TE Connectivity

Product Change Notification: PCN-26-286187

ORWH-SS(SH)-1**D1 and ORWH- SH-1**DM1

ORWH-SS(SH)-1**D1 Marking before change

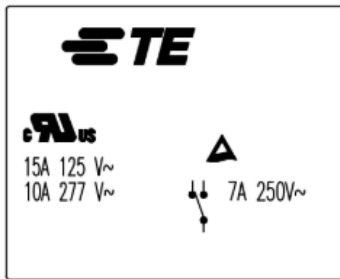
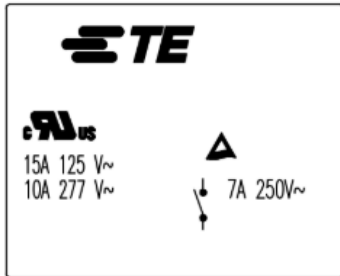
To ensure the sustainable development of the product, while consistently maintaining alignment and continuity with product certification, we are updating the product marking contents for certain types.

See image for details.

ORWH-SS(SH)-1**D1 Marking after change

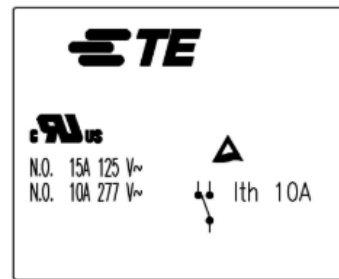
See image for details.
